LR-N00-0405
LCR H00-05

**REQUEST FOR LICENSE AMENDMENT
INCREASED LICENSED POWER LEVEL
HOPE CREEK GENERATING STATION
FACILITY OPERATING LICENSE NO. NPF-57
DOCKET NO. 50-354**

**HOPE CREEK GENERATING STATION
FACILITY OPERATING LICENSE NO. NPF-57
DOCKET NO. 50-354
CHANGE TO TECHNICAL SPECIFICATIONS
INCREASED LICENSED POWER LEVEL**

Figure 3.4.6.1-3
Core Critical Heatup and Cooldown Pressure/Temperature Limits - Curve C

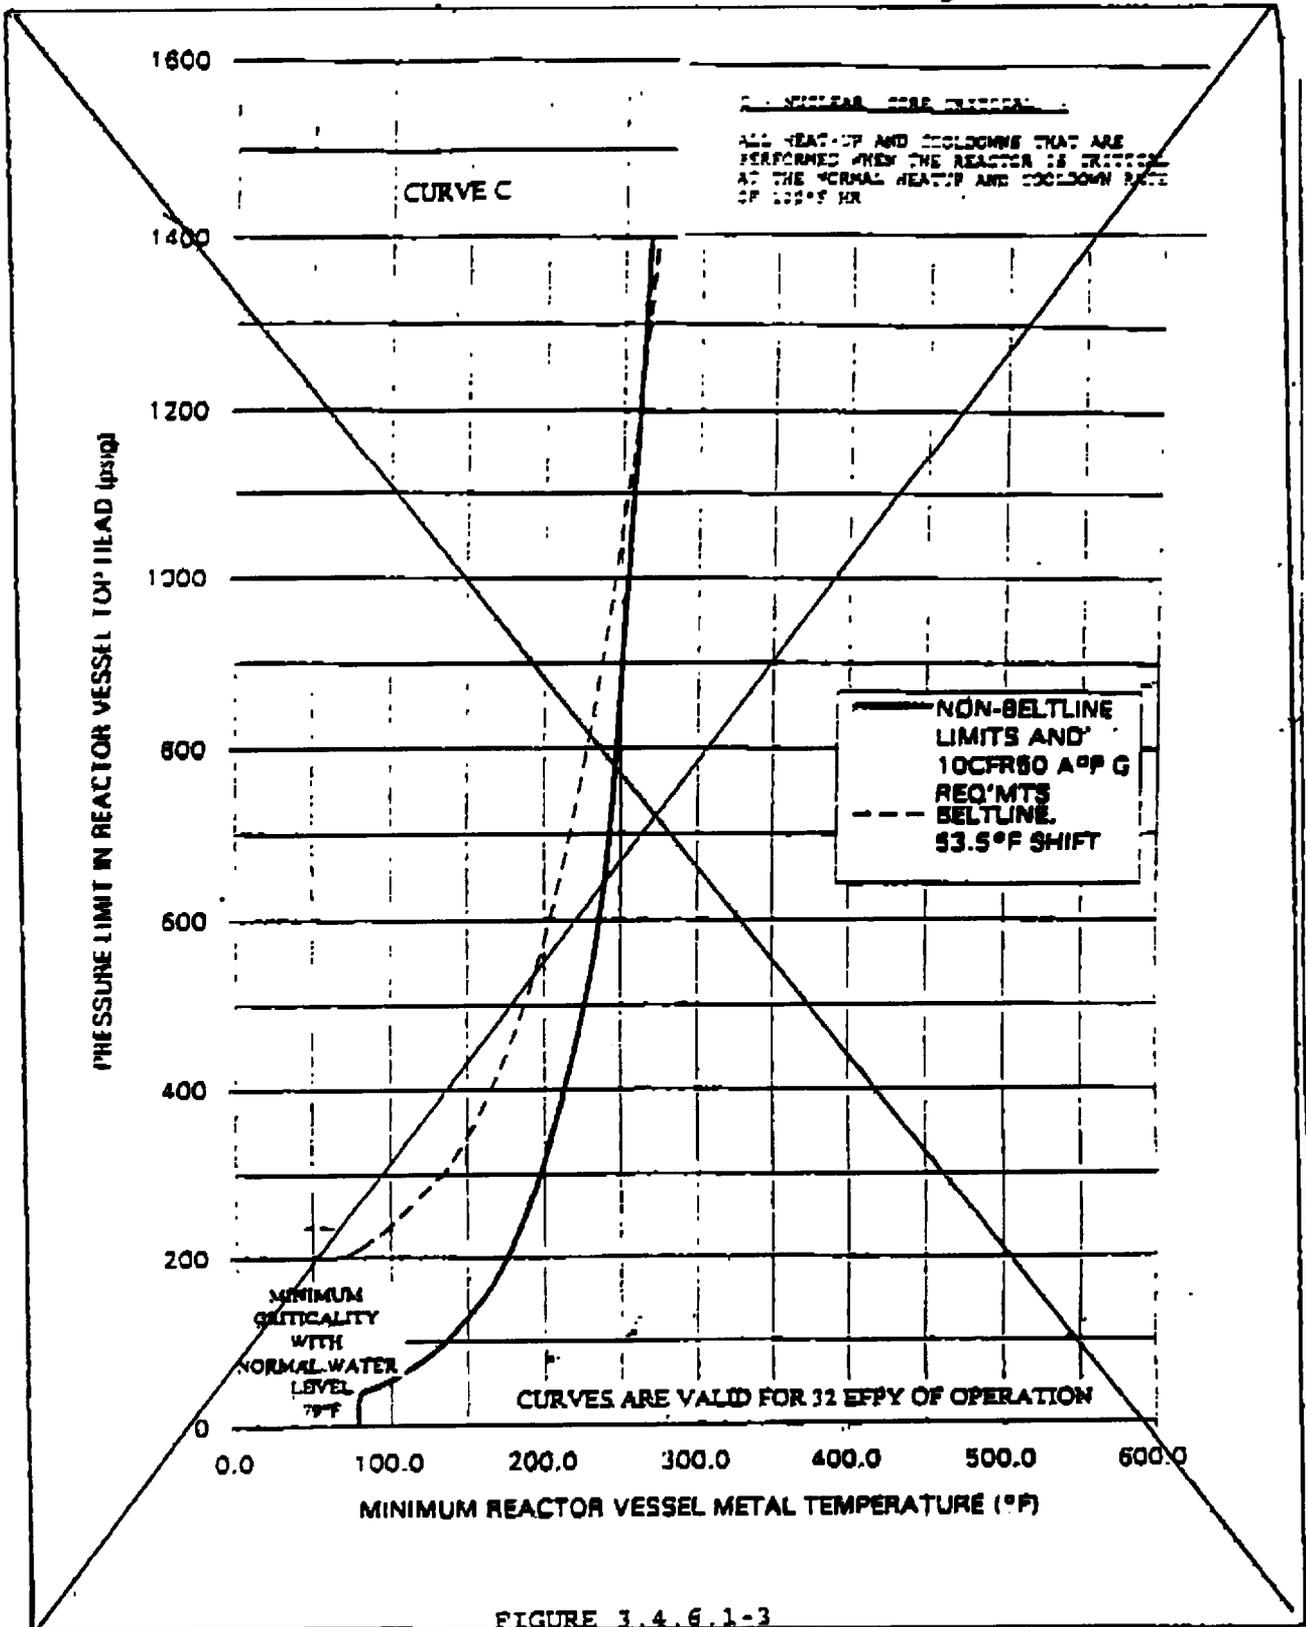
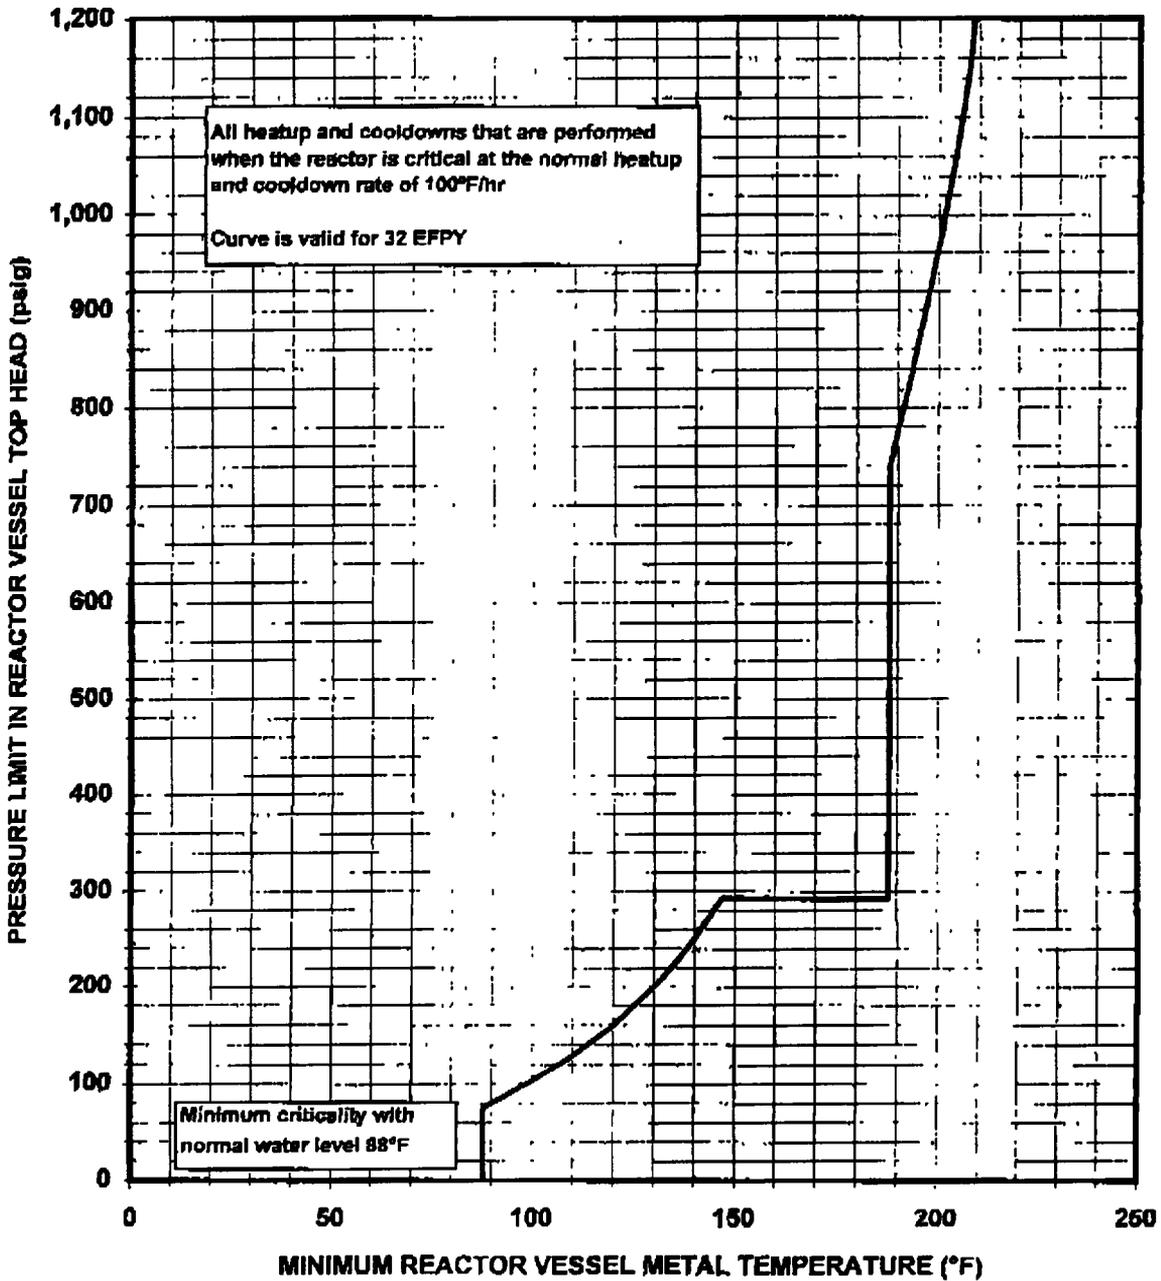
1. Technical Specification Figures 3.4.6.1-1, 3.4.6.1-2 and 3.4.6.1-3, pressure-temperature limit curves for hydrostatic testing, non-nuclear heatup and cooldown, and critical operation, and their associated Bases are revised to support the increase in core power based on uprated fluence projections.
2. Surveillance Requirement 4.4.6.1.4 is being revised to be made consistent with the limit on reactor vessel flange and head flange metal temperature in TS 3.4.6.1.d.

1. Technical Specification Figures 3.4.6.1-1, 3.4.6.1-2 and 3.4.6.1-3, pressure-temperature limit curves for hydrostatic testing, non-nuclear heatup and cooldown, and critical operation, and their associated Bases are revised to support the increase in core power based on updated fluence projections.
2. Surveillance Requirement 4.4.6.1.4 is being revised to be made consistent with the limit on reactor vessel flange and head flange metal temperature in TS 3.4.6.1.d.

4.4.6.1.2 The reactor coolant system temperature and pressure shall be determined to be to the right of the criticality limit line of Figure 3.4.6.1-3 within 15 minutes prior to the withdrawal of control rods to bring the reactor to criticality and at least once per 30 minutes during system heatup.

FIGURE B 3/4 4.6-1 FAST NEUTRON FLUENCE (>1 MeV)
AT 1/4 T AS A FUNCTION OF SERVICE LIFE

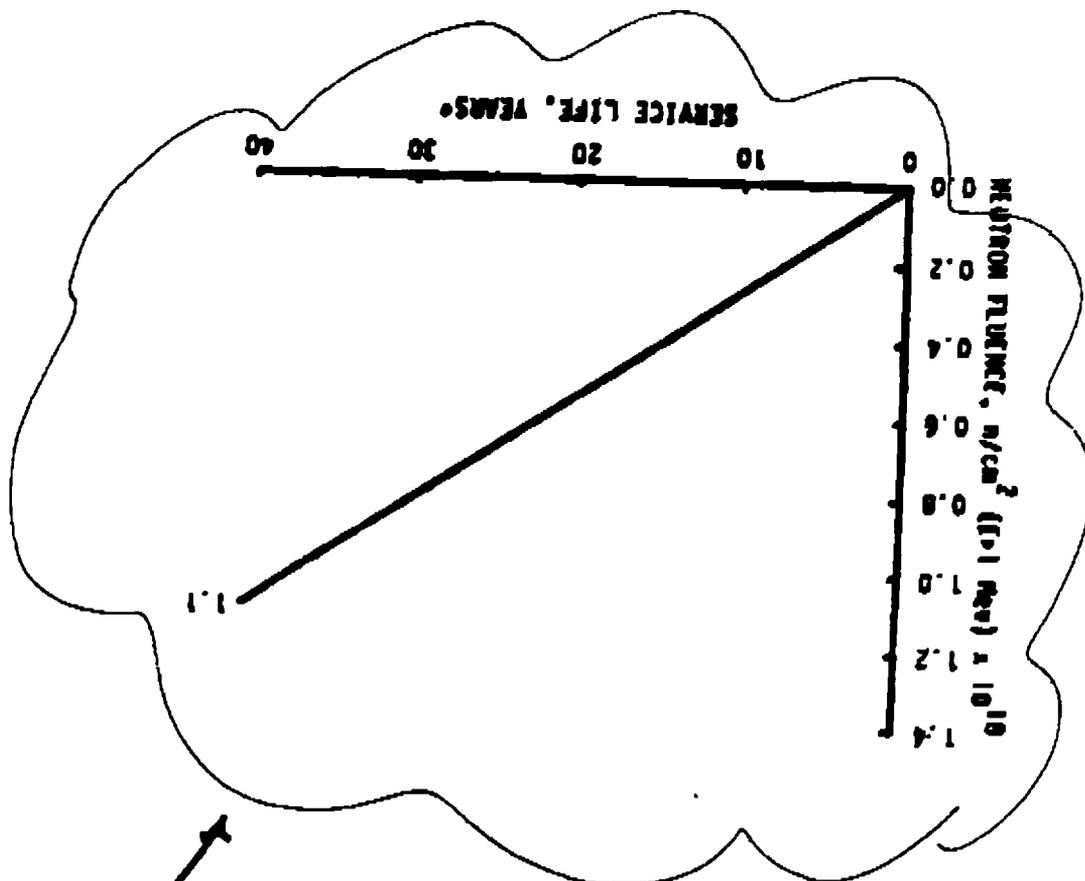
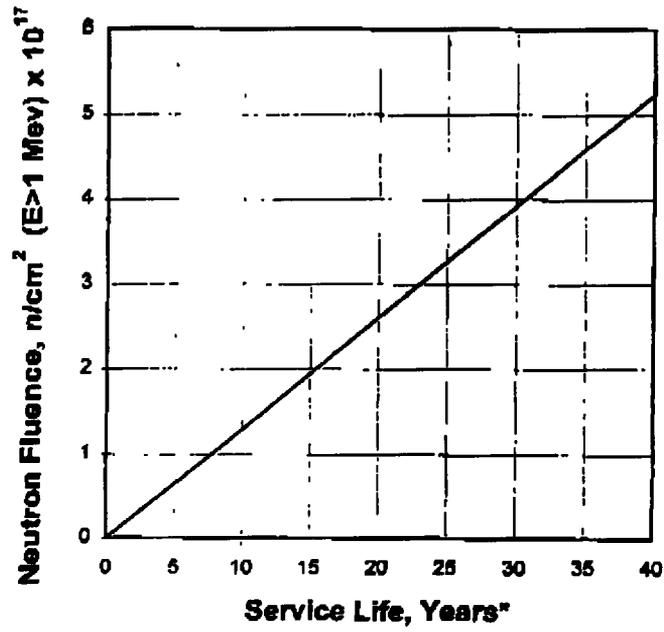
The reactor vessel materials have been tested to determine their initial RT_{WT}. The results of some of these tests are shown in Table B 3/4.4.6-1. Reactor operation and resultant fast neutron, E greater than 1 MeV, irradiation will cause an increase in the RT_{WT}. Therefore, an adjusted reference temperature, based upon the fluence, nickel content and copper content of the material in question, can be predicted using Basis Figure B 3/4.4.6-1 and the recommendations of Regulatory Guide 1.99, Rev. 2, "Radiation Embrittlement of Reactor Vessel Material". The pressure/temperature limit curves, Figures 3.4.6.1-1, 3.4.6.1-2, and 3.4.6.1-3, includes an assumed shift in RT_{WT} for the end of life fluence.
